**INTERNATIONAL CODE COUNCIL (ICC)
Code Technology Committee (CTC)**

**FINAL REPORT OF THE CTC
AREA OF STUDY – CLIMBABLE GUARDS**

**May 21, 2008
Four Points Sheraton BWI Airport
Baltimore, Maryland**

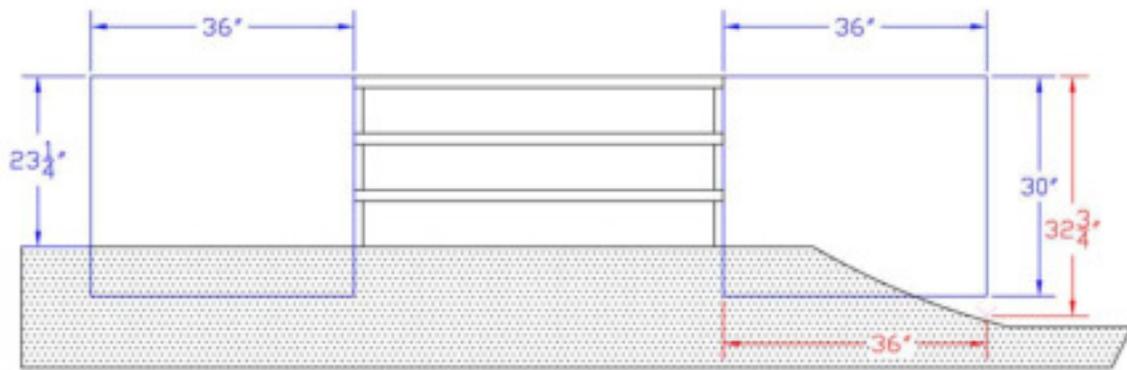
IBC 1013.1. Laundry lists of items in the code are typically not all-inclusive. The word “including” provides this clarification in the following sections as well. This section is divided into two paragraphs with the second paragraph dealing with glass and glazing without a change in intent. The key part of this change to IBC 1013.1 is submitted in order to clarify how the height measurement which triggers the guard requirement is made relative to proximity to the adjacent fall-off. This is illustrated in the following figure:

The view is taken from the landing of a 3 riser stair, looking towards the face of the risers.

1013.1 (IFC [B] 1013.1) (Supp) Where required. Guards shall be located along open-sided walking surfaces, including mezzanines, equipment platforms, stairways, stairs, ramps and landings, that are located more than 30 inches measured vertically to the floor or grade below at any point within 36 inches (914 mm) horizontally to the edge of the open side above the floor or grade below. Guards shall be adequate in strength and attachment in accordance with Section 1607.7. ~~Where glass is used to provide a guard or as a portion of the guard system, the guard shall also comply with Section 2407. Guards shall also be located along glazed sides of stairways, ramps and landings that are located more than 30 inches (762 mm) above the floor or grade below where the glazing provided does not meet the strength and attachment requirements in Section 1607.7.~~

1013.1.1 (IFC [B] 1013.1.1) Glazing. Where glass is used to provide a guard or as a portion of the guard system, the guard shall also comply with Section 2407. Where the glazing provided does not meet the strength and attachment requirements in Section 1607.7, complying guards shall also be located along glazed sides of open-sided walking surfaces.
